Stop Use & Product Recall

3M™ PROTECTA® Cobra Rope Grab AC202D

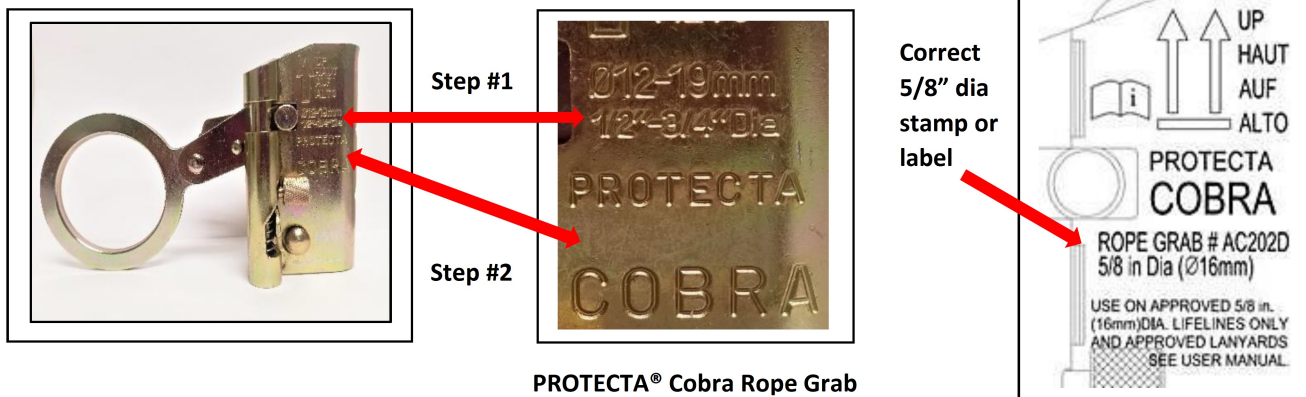
3M Fall Protection has determined that the 3M™ PROTECTA® Cobra Mobile/Manual Rope Grab AC202D is incorrectly stamped for use with 1/2 to 3/4 inch diameter rope on the exterior body of the unit. This Cobra Rope Grab is certified for use **ONLY** with 5/8 inch diameter polyester or polypropylene rope. All marketing information and the Instructions for Use (IFU) for this rope grab correctly identify the size of rope to be used as 5/8 inch polyester/polypropylene rope.

Step 1: Verify the rope diameter is stamped **1/2"—3/4" Dia** on the front side of the unit

Step 2: Verify the rope grab is stamped **PROTECTA COBRA** on the front side of the unit

Note: If the unit is stamped 5/8 inch diameter **OR** if the unit has a white label showing 5/8 inch diameter, then the unit is safe to return to normal use (see image on right for correct 5/8" diameter marking).

If the information in Step 1 and Step 2 is stamped onto the side of the rope grab as illustrated above, remove the unit from service immediately. Owners of AC202D Cobra Rope Grabs can choose one of the following options for each affected rope grab they own:

1. A free, new, properly marked replacement AC202D Cobra Rope Grab; or
2. A check for \$100.

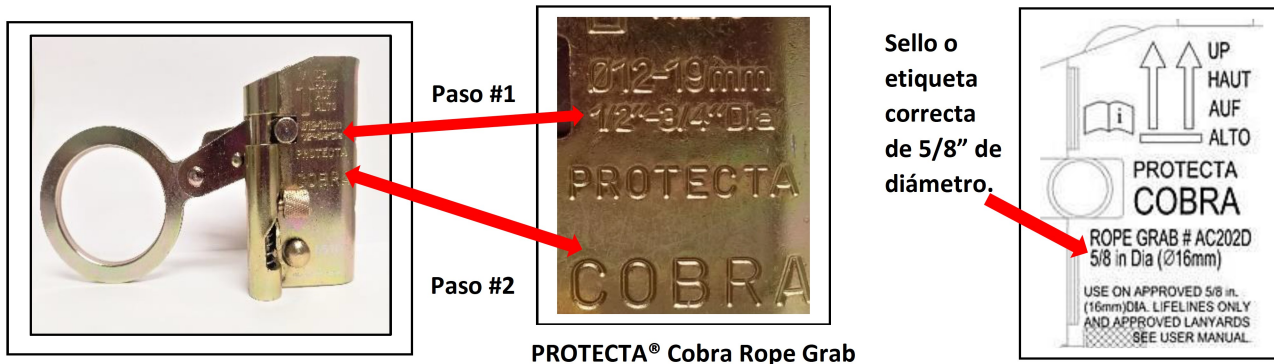
3M Fall Protection ha determinado que el producto 3M™ PROTECTA® Cobra Mobile/Manual Rope Grab AC202D está sellado incorrectamente en la parte exterior de la unidad para el uso de cuerdas con diámetro de 1/2 a 3/4 de pulgada. La Cobra Rope Grab está certificada **SOLAMENTE** para el uso de cuerdas de poliéster o polipropileno con diámetro de 5/8 de pulgada. Toda la información de mercadeo y las Instrucciones de Uso para este producto identifican correctamente el tamaño de la cuerda como 5/8 de pulgada de poliéster/polipropileno.

Paso 1: Verifique que el diámetro de la cuerda en la parte frontal de la unidad sea de **1/2" – 3/4" de diámetro**.

Paso 2: Verifique que la parte frontal de la unidad contenga **PROTECTA COBRA**.

Nota: Si la unidad esta sellada con 5/8" de diámetro **O** contiene una etiqueta blanca mostrando 5/8" de diámetro, la unidad podrá regresar a su uso normal (para la identificación de la etiqueta correcta ver imagen a la derecha).

Si la información del Paso 1 y Paso 2 se encuentra a un costado de la unidad, así como muestran las imágenes previas, favor de remover todas las unidades que se encuentren en uso de manera inmediata. Propietarios del producto AC202D Cobra Rope Grab pueden elegir de las siguientes opciones por cada Cobra Rope Grab que poseen:

1. Una nueva y gratis AC202D Cobra Rope Grab marcada de manera correcta; o
2. Un reembolso de \$100.00 USD vía cheque.
